# marantz

model number 18	bulletin number 69-01/18-1	date
for serial numbers	to	
subject REPLACEMENT OF DIODES IN 12 VOLT SUPPLY

model number 18	bulletin number 69-2/18-2	date
for serial numbers	to	
subject REPLACEMENT OF REFERENCE DIODES IN POWER AMPLIFIER.

model number 18	bulletin number M-18-8
for serial numbers ALL	
subject LIGHT CELL REPLACEMENT	
engineering approval <i>[Signature]</i>	date 11-25-75

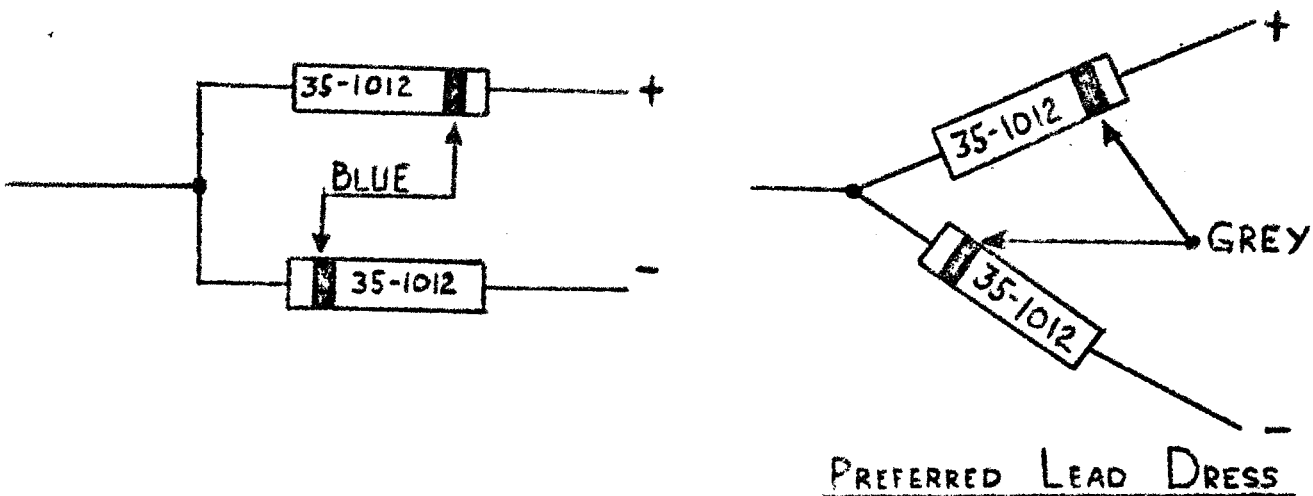
For improved reliability and performance the two Zener Diodes (CR-10 & CR-11) are being replaced by a new type. These diodes are located behind the power transformer on the top main chassis. They provide regulation for the FM sections, scope display and tone amplifier. Their failure will result in a loss of FM operation, scope display or if the fault is in the plus side of the 12V supply (CR-10) it will cause a loss of output on both channels.

The older type, to be replaced, is identified by a blue band. Its leads will be dressed at right angles. the NEW TYPE is identified by a GREY band. This is illustrated below with a drawing showing the old and the preferred new installation.

The part number for the diodes remains the same: 35-1012

**FIGURE I:**  
MR9-054d

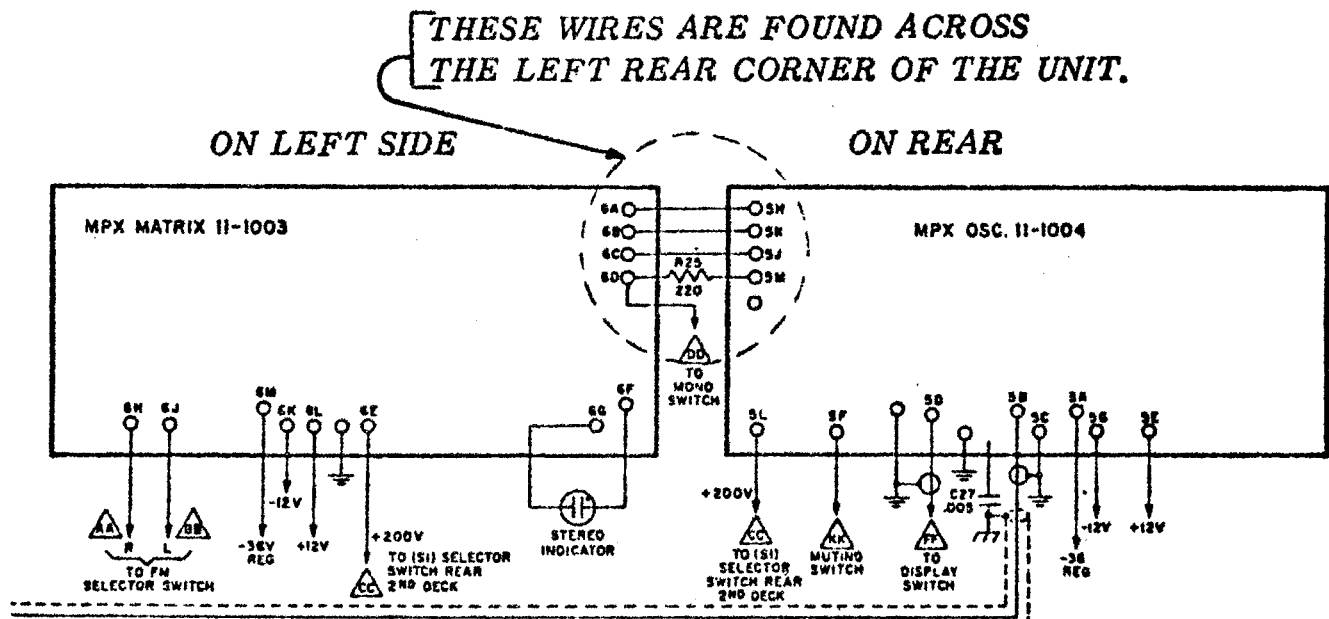
The following circuit modification is designed to correct the intermittent stereo operation in the FM mode which results from improper operation of the STEREO PHOTOSWITCH, LDR602.

1. REMOVE the three wires between the terminals of the MPX MATRIX board and the MPX OSCILLATOR board (See FIG.1). Also remove one side of resistor R-25.
2. REMOVE the two screws which secure the MPX Matrix board to the main chassis. Carefully pull the board away to expose the foil side.
3. INSTALL two insulated wire JUMPERS across both sides of the STEREO PHOTOSWITCH, LDR602 as shown in FIG.2. This effectively bypasses its operation.
4. REPLACE the matrix board on the chassis and re-solder the wires and resistor removed in step one above.

NOTE: IF THE PREVIOUS WIRES WERE SOLID, REPLACE THEM WITH STRANDED WIRE FOR GREATER FLEXIBILITY.

Replacement  
LIGHT CELL ASSEMBLY, LDR501  
P/N 331-1005-000

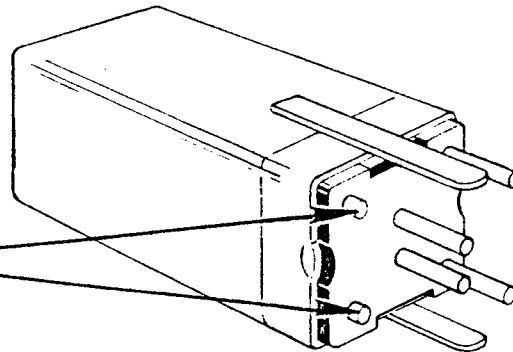
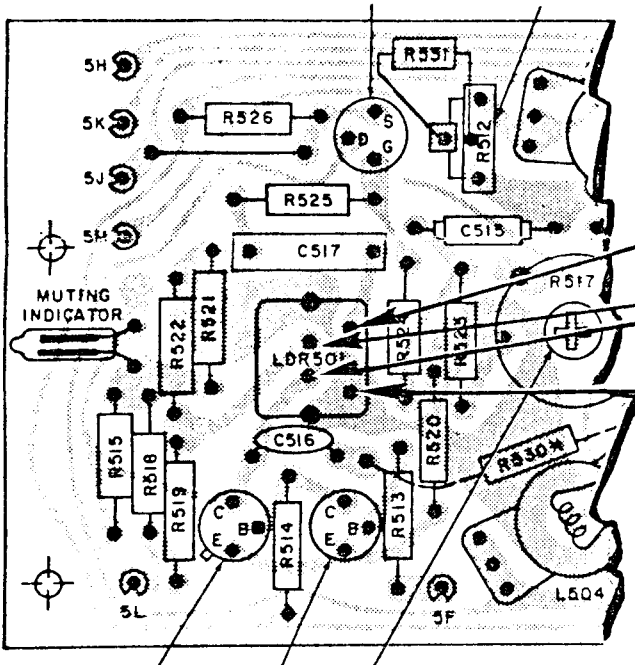
The original LIGHT CELL ASSEMBLY, Ref. Desig. LDR501, Part Number 11-1010 is no longer available and has been replaced by Part Number 331-1005-000.

Prior to installation it is necessary to modify the replacement Light Cell Assembly and the Model 18 MPX Oscillator Board as described below;

Cut (2) Leads

Enlarge PCB Holes  
[to accommodate larger  
lead diameter of replace-  
ment LDR501]
